RESOLUTION NO R-2014-082

A RESOLUTION OF THE CITY COMMISSION OF THE CITY OF HOLLYWOOD, FLORIDA, RECOMMENDING AN AMENDMENT TO THE BROWARD COUNTY TRAFFICWAYS PLAN TO ADD THE "CONTEXT SENSITIVE CORRIDOR" DESIGNATION TO A PORTION OF DIXIE HIGHWAY/21ST AVENUE BETWEEN PEMBROKE ROAD AND SHERIDAN STREET.

**Re: Application for Broward County Trafficways Amendment
Context Sensitive Corridor designation
Dixie Highway/21st Avenue from Pembroke Road to Sheridan Street
City of Hollywood**

RESPONSE TO COMMENTS

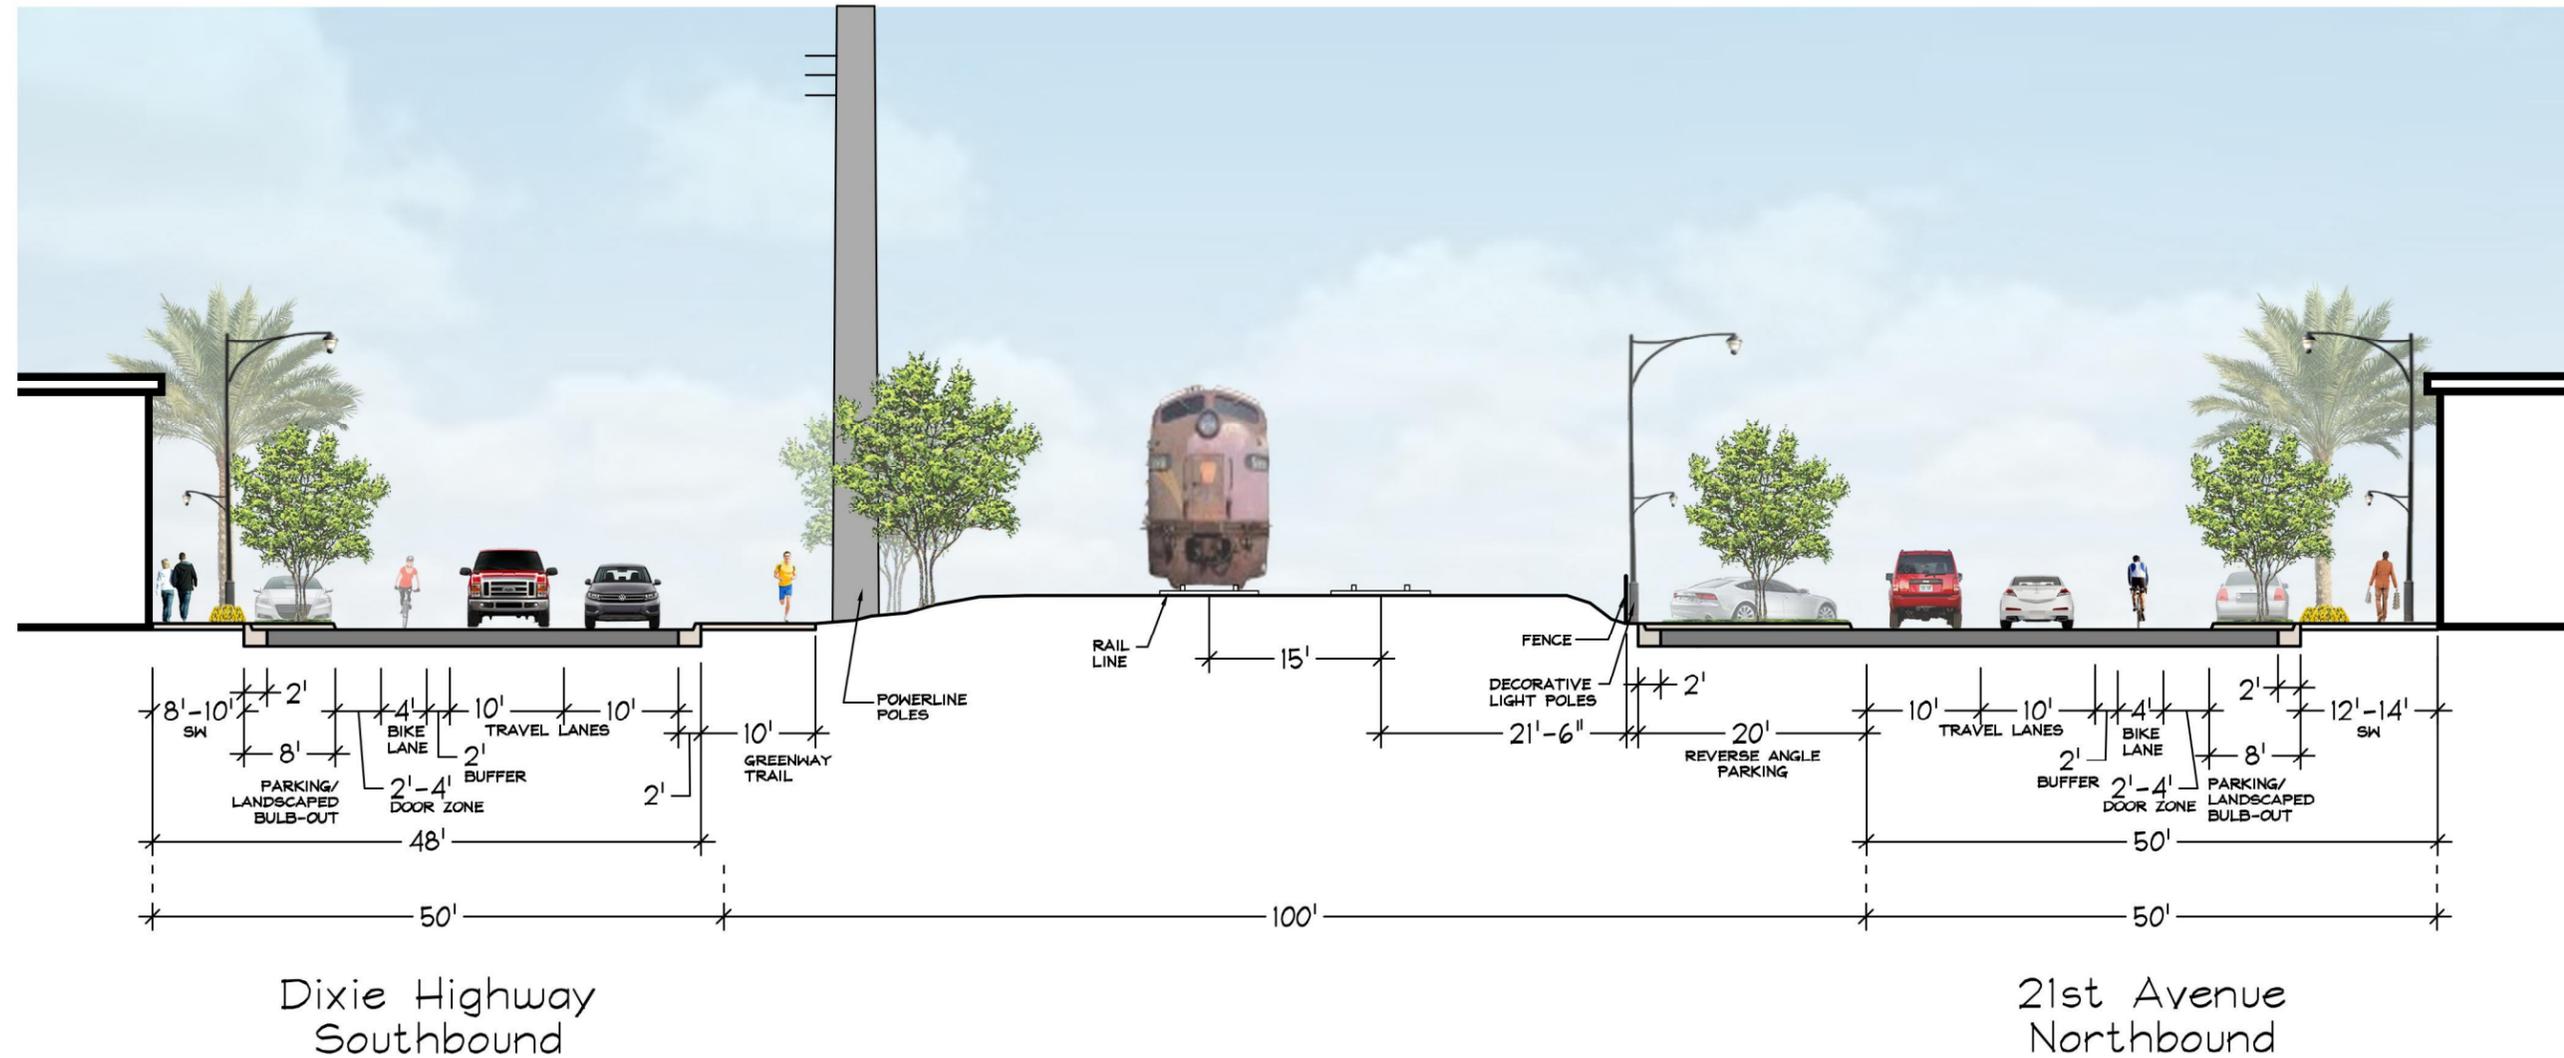
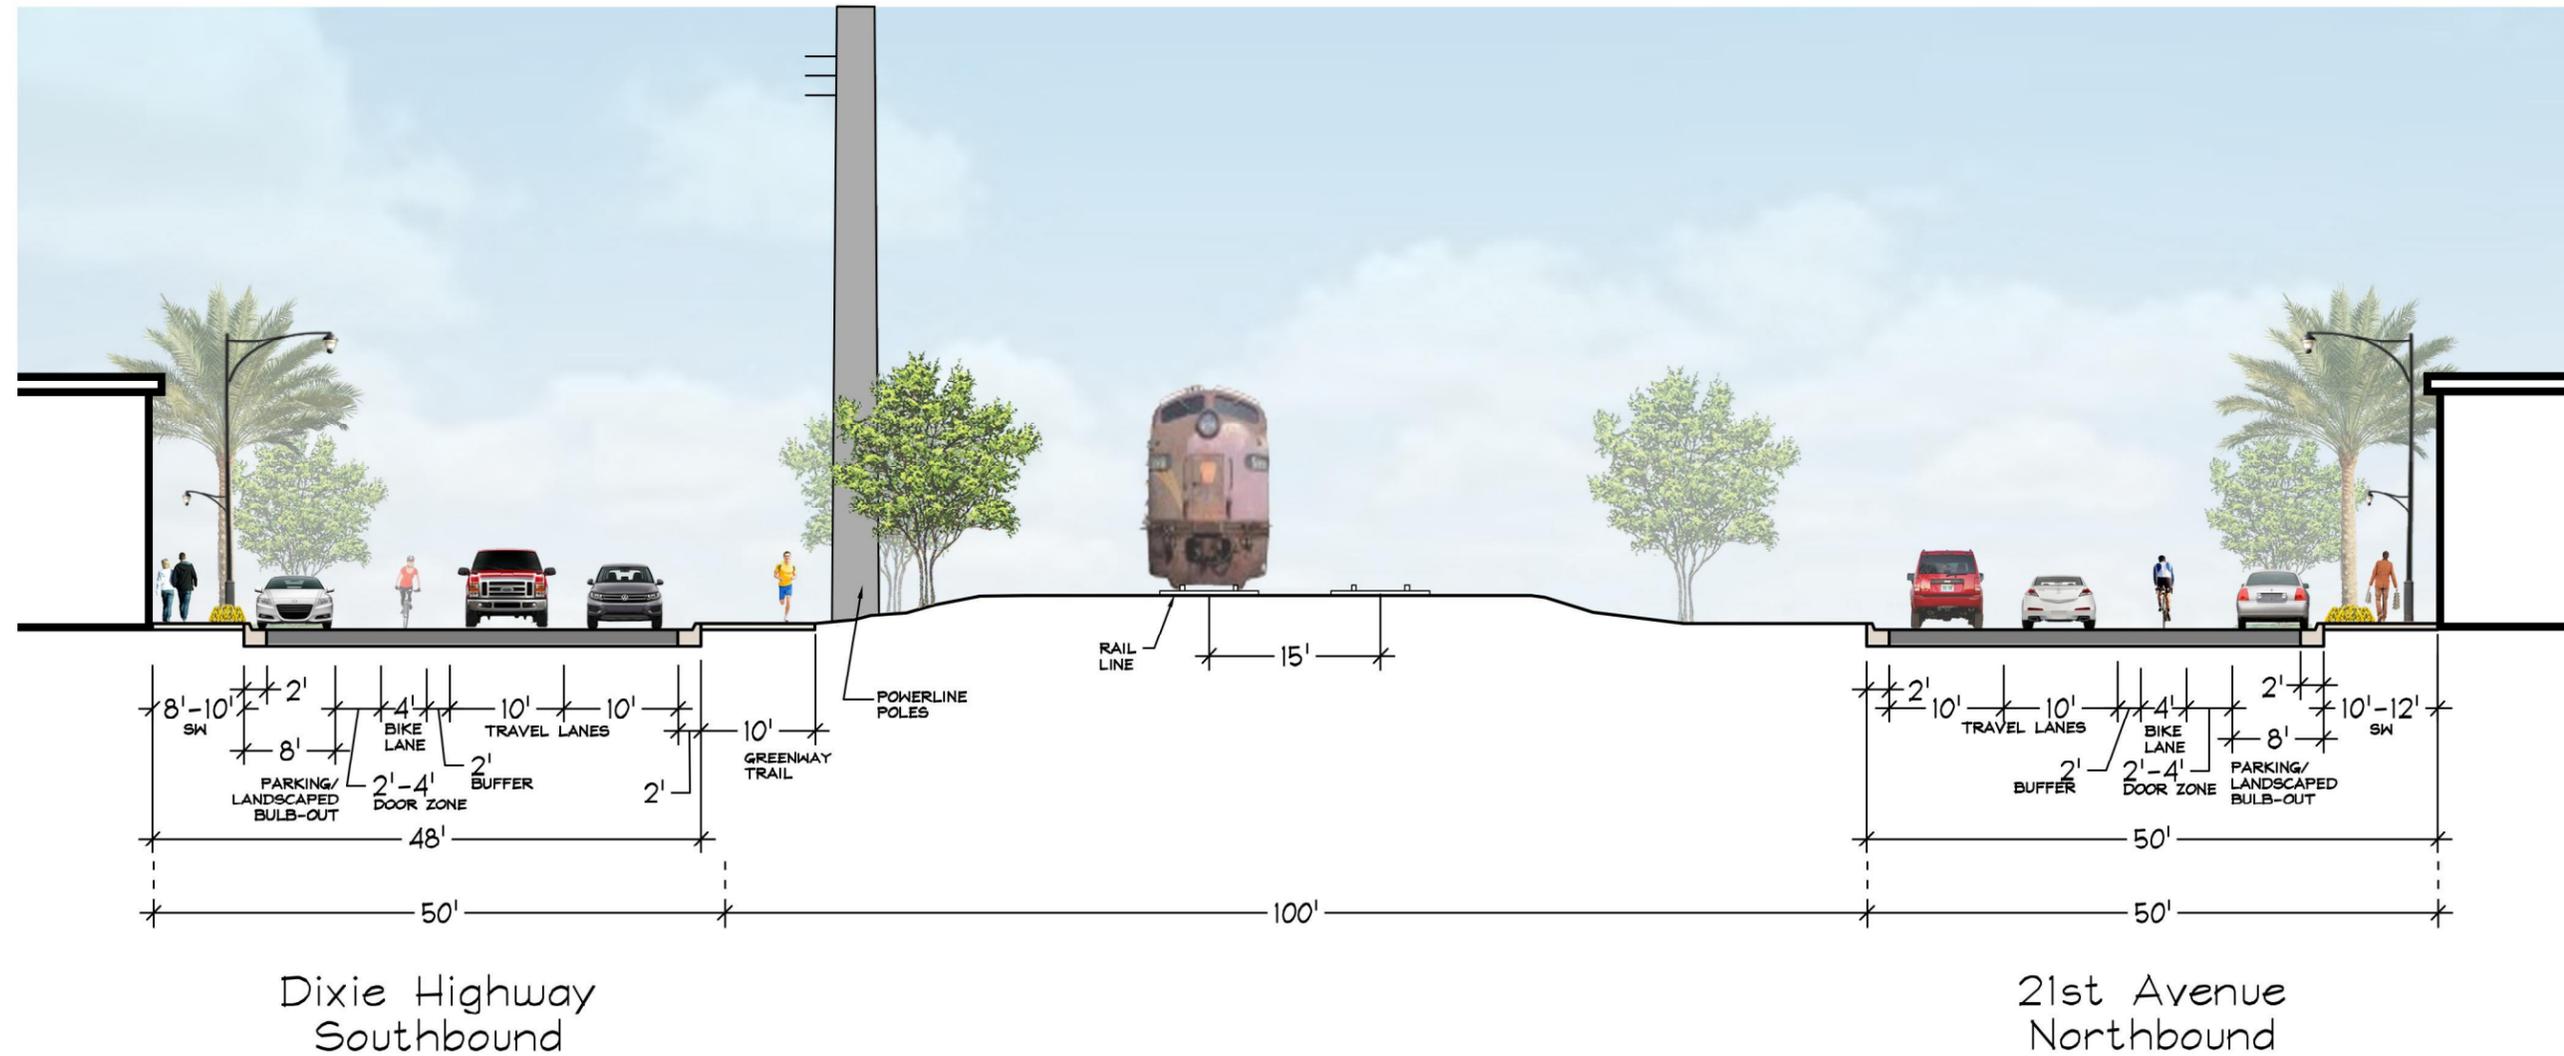
1. On-street parking is shown on Exhibits A, B, and C but is not specifically listed as a design element in Section A of the Letter of Application. All design elements proposed for the corridor including street trees, decorative lighting, etc. should be listed in the narrative in Section A.

1. On-street parking is shown on Exhibits A, B, and C but is not specifically listed as a design element in Section A of the Letter of Application. All design elements proposed for the corridor including street trees, decorative lighting, etc. should be listed in the narrative in Section A.

Response: On-street parking is included in the narrative for Section A; however, we modified the narrative to specify an eight (8) foot (including curb and gutter) on-street parking lane with intermittent landscaped bulb-outs. In addition, we modified the narrative for Section A to include street trees, landscaping, and decorative lighting.
